2. Public Rights of Way (PROW)

- 2.1. This section seeks to address the comments that were made by the Public Rights of Way Officer dated 8 January 2024. A meeting was held with Officers on 13 February 2024 and the approach towards this response agreed.
- 2.2. Following a review of the comments made, it is considered that the matters raised are addressed under the following subheadings, taken from the holding objection.

Figure 1 – Proposed Temporary Diversion Route

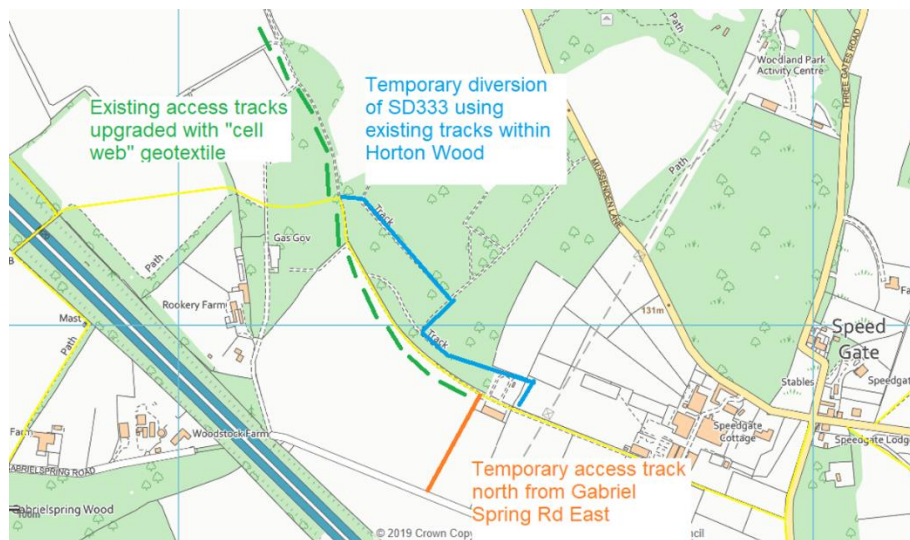
Site access during construction and operation appear to be aligned along Public Footpath SD333

- 2.4. It is acknowledged that during the construction period traffic will be routed along the existing track through the site which correlates with the alignment of Footpath SD333. As such the applicant is proposing a temporary diversion route for the construction period as detailed below. It is proposed that this alternative route will be clearly signposted so that users are able to continue to utilise tracks safely during this construction period.

- 2.5. It is understood that the temporary diversion will be agreed with Kent County Council under a separate agreement prior to any works commencing on site.
